ND-16-1892
10 CFR 50.90
10 CFR 52.63

Southern Nuclear Operating Company
Vogtle Electric Generating Plant Units 3 and 4
Request for License Amendment and Exemption Regarding
Passive Core Cooling System (PXS) Condensate Return (LAR-16-026)

Southern Nuclear Operating Company
Vogtle Electric Generating Plant Units 3 and 4

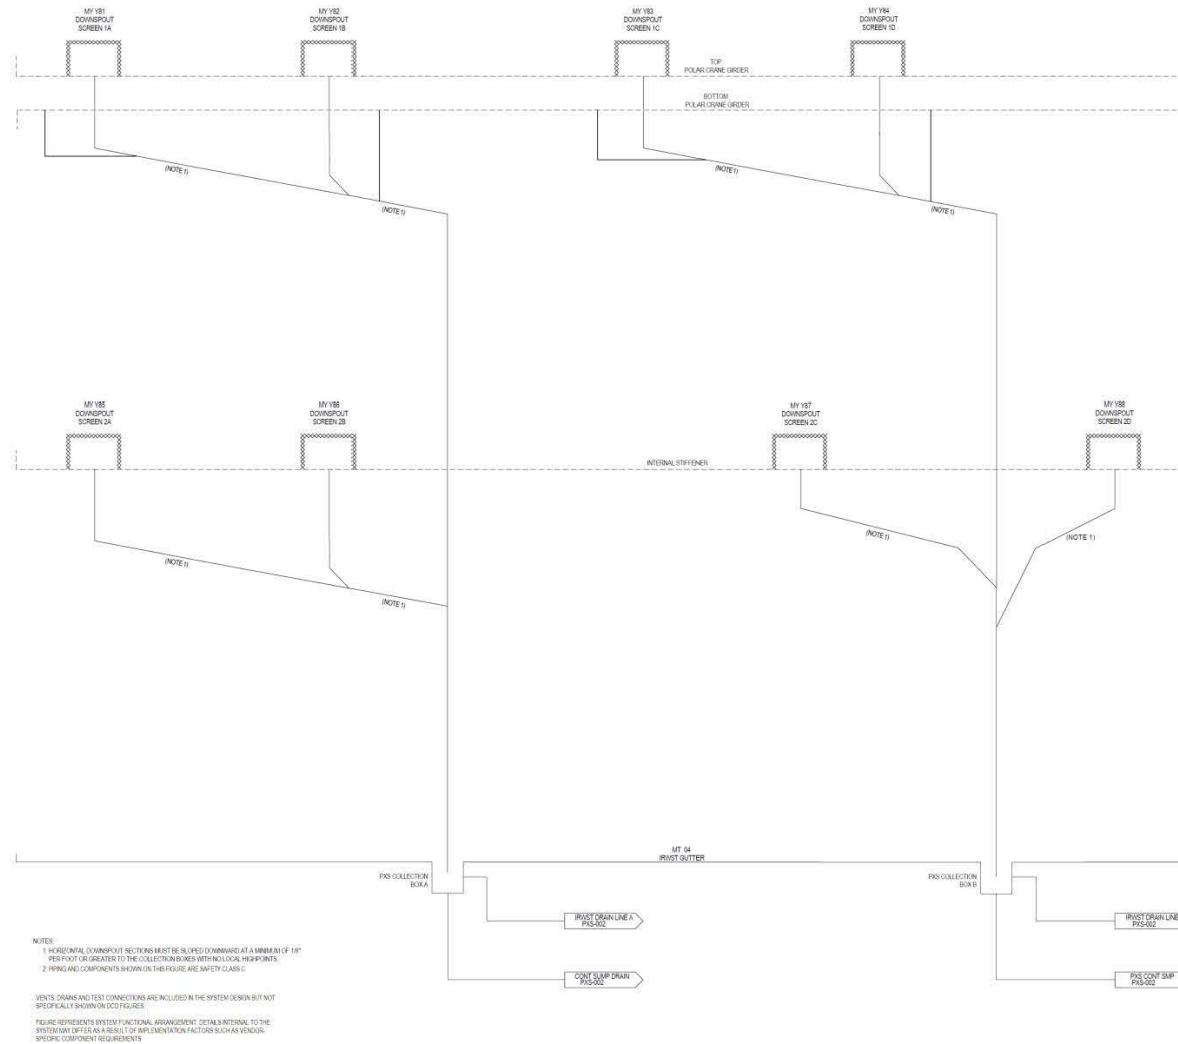
The UFSAR Section 6.3, Figure 6.3-1 (Sheet 2 of 3) [that was Figure 6.3-2] is revised in the upper portion of the figure to relocate the IRWST gutter to a new sheet 3, and to include continuation flags for condensate returning to the IRWST originating from PXS Collection Boxes A and B in the IRWST gutter as shown below. Individual flags are shown larger for clarity below.
